January 22, 2024

Re: Hamilton-Wenham Regional High School Athletic Campus Redevelopment  
Site Plan Review Application and Stormwater Management Permit Application –  
Response to Comments  
Gale JN 718601

DRAWING NO.  
**C102B**

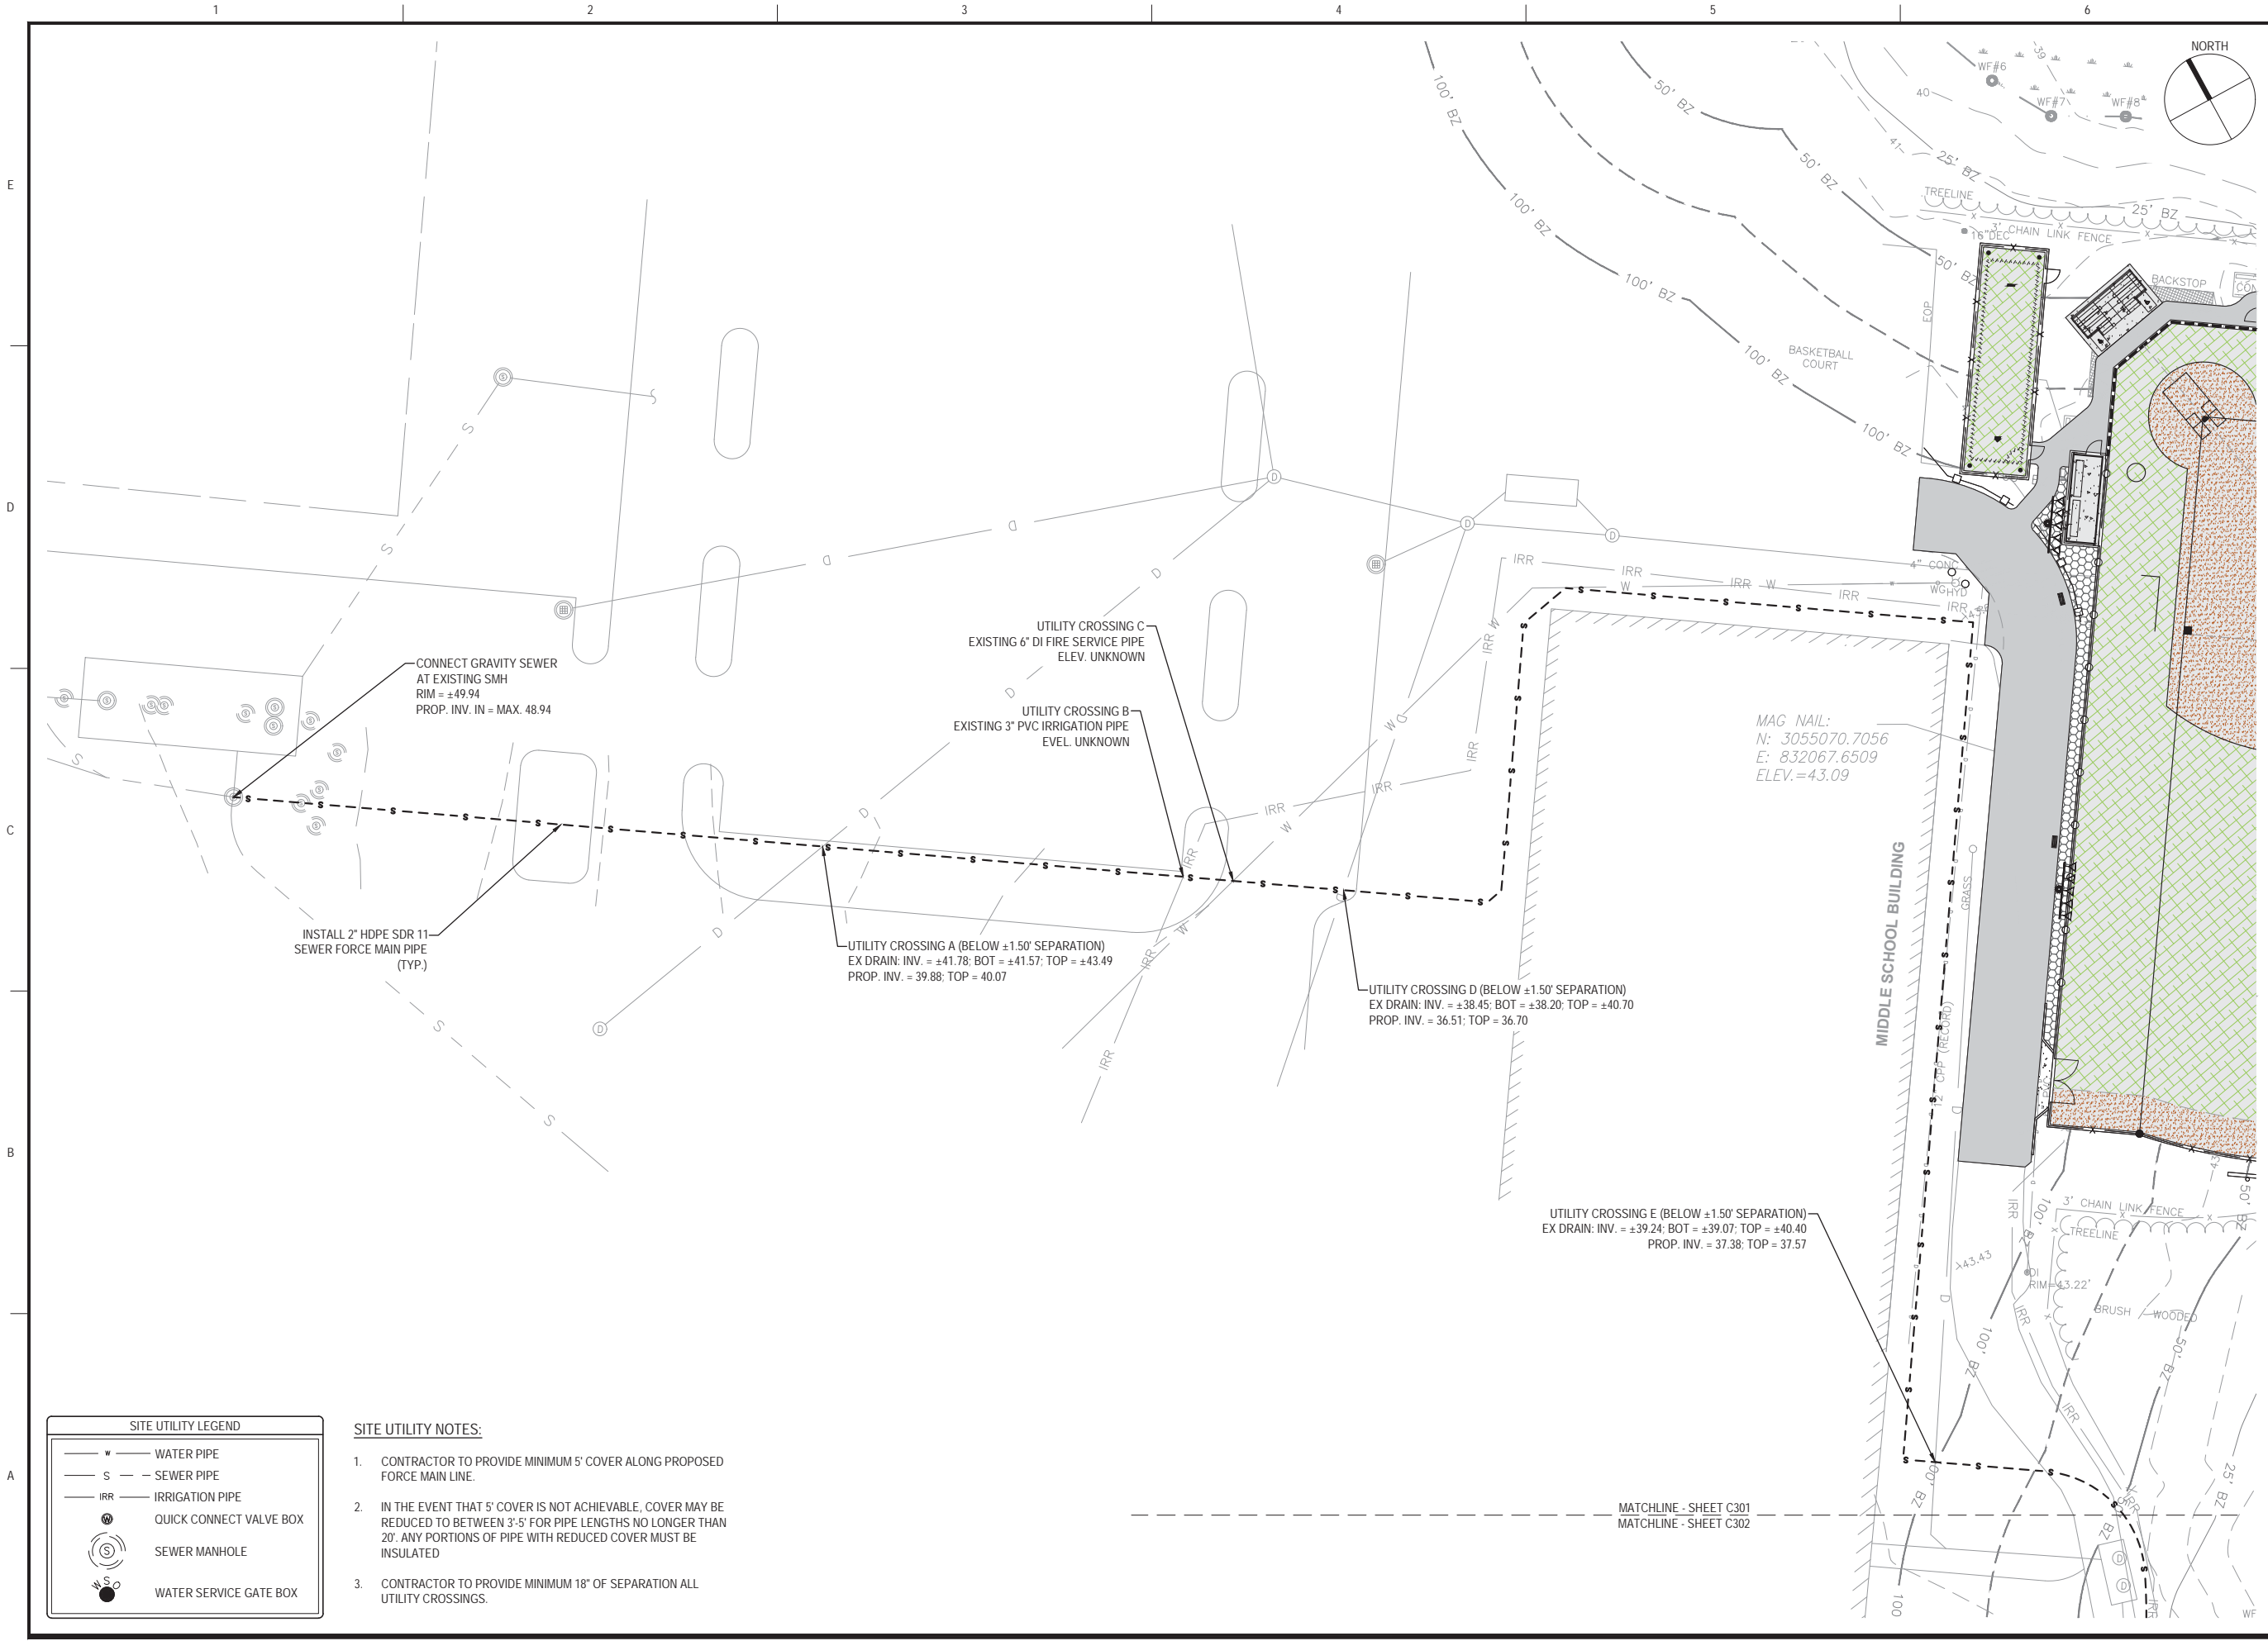
- 8. Show the proposed “front yard “setbacks to the sideline of Longmeadow Way for the Amenities Building and possibly the storage units or seek relief. Refer to Comment 2 (ZBL §10.7.5 14).**

- 9. Show any directional or way finding signage (ZBL §10.7.5 16).**

- 23. Expand the parking supply if required to accommodate the calculated parking demand (Comment ) or provide a parking management plan. Provision should be made for dropping off athletes and spectators and for turnaround of vehicles unable to locate a parking space. Provide a hammerhead turnaround at the east end of the existing parking field to accommodate drop-offs and turnarounds.**

- 24. The School District may not want private passenger vehicles circulating around the school building. Bus drop-offs may be appropriate in front of the Amenities Building. As no turnaround is provided, busses would exit by circulating behind the school building. Place a sign at the east end of the parking area stating, "Busses Only Beyond this Point."**

Response: The front yard setback for the proposed Amenities Building has been provided on Plan Sheets C102 and C102B.

Response: Signage will be provided, as requested. Refer to Plan Sheet C102 and C102B.

Response: The plans have been updated to provide a hammerhead turnaround, as requested, along with three (3) additional parking spaces by the Amenities Building. Refer to Plan Sheets C102 and C102B.

Response: HWRSD has indicated that bus drop-offs are at the front of the school and the drive around the rear of the school is used for fire access only. An "Authorized Vehicles Only" sign (MUTCD R5-11) has been incorporated into the design, prefer to Plan Sheet C102B.

**2 SIDEWALK PAVEMENT SECTION**  
N.T.S.

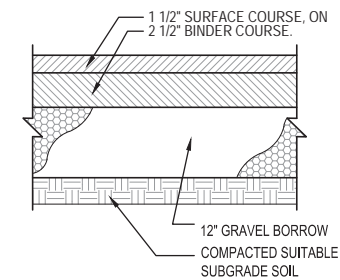
**41. Sidewalk Pavement Section – We recommend limiting the thickness of the “Dense Graded Crushed Stone” layer to approximately 2-inches. Refer to Comment 40.**

Response: Sidewalk Pavement Section Detail 2 on Plan Sheet C502 has been updated, as requested.

5 HANDICAP ACCESSIBLE RAMP  
N.T.S.

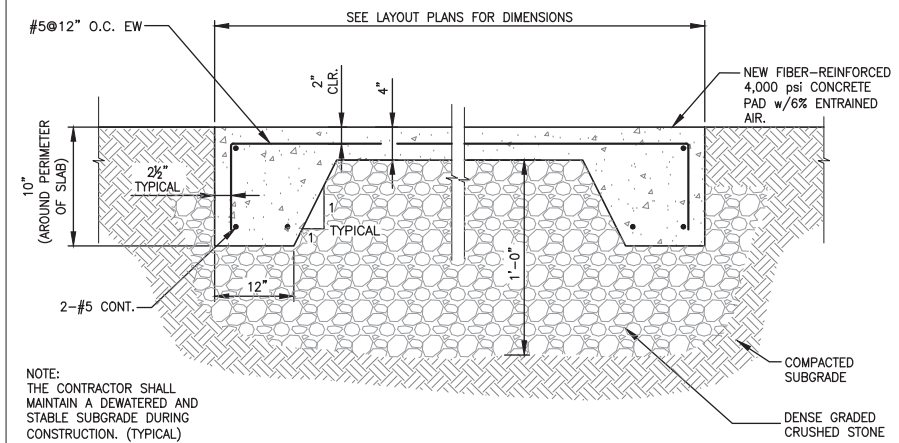
**42. Handicapped Accessible Ramp – Show maximum slope. The specified length of 14-ft. would only apply to a specific elevation change.**

Response: Handicap Accessible Ramp Detail 5 on Plan Sheet C503 has been updated to show maximum slope.

4 SEGMENTAL BLOCK RETAINING WALL  
N.T.S.

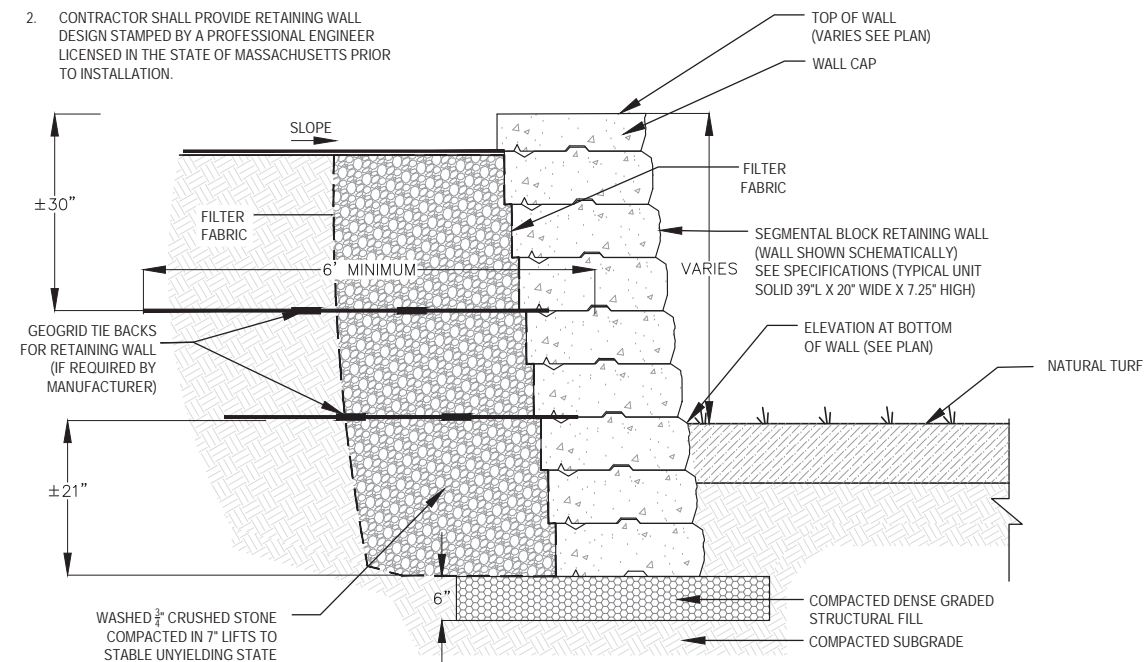
**44. Segmental Block Retaining Wall – Require site specific soil testing as part of shop drawing review. Specify the free-draining backflow material.**

Response: The Segmental Block Retaining Wall Detail 4 on Plan Sheet C514 has been updated to specify the use of site specific soil testing as part of the shop drawing review and the free draining backfill material specified.

DRAWING NO.	IS1
1 OF 2

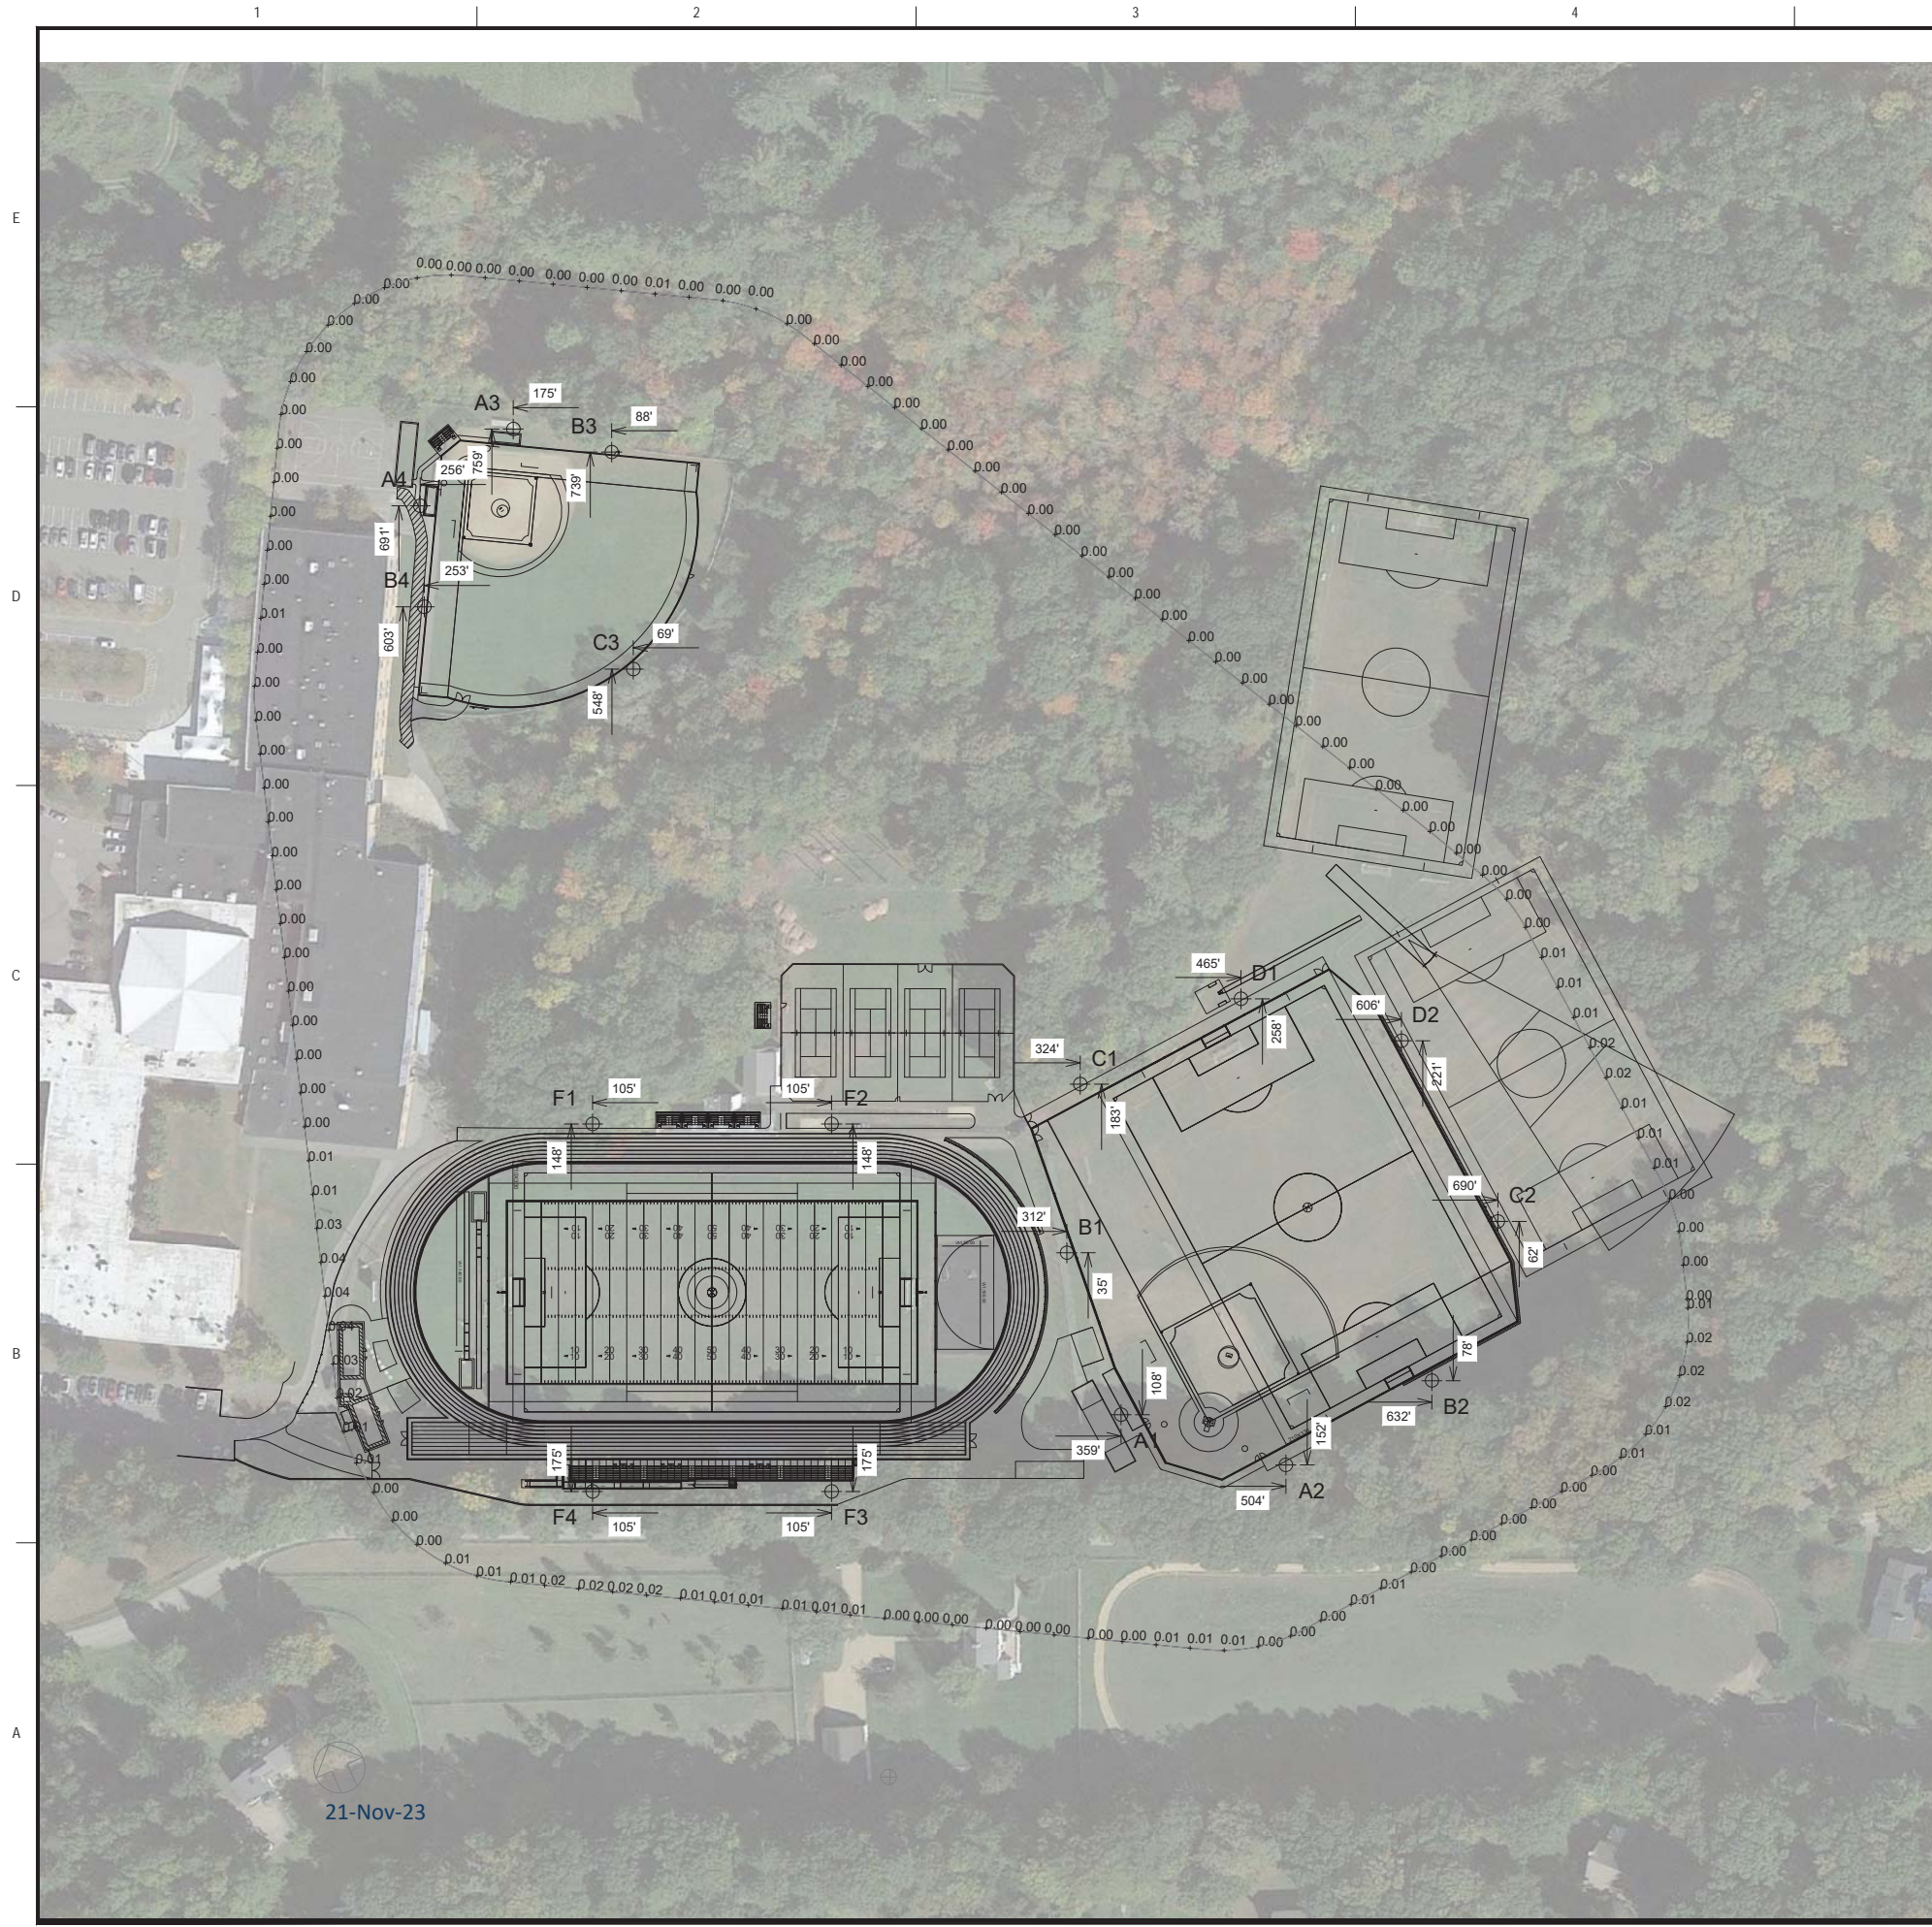
**12. Provide a complete photometric of the Athletic Campus, not just the cutoff perimeter line.**

Response: The updated photometric for the campus has been provided. Refer to updated Plan Sheets IS1 and IS2.
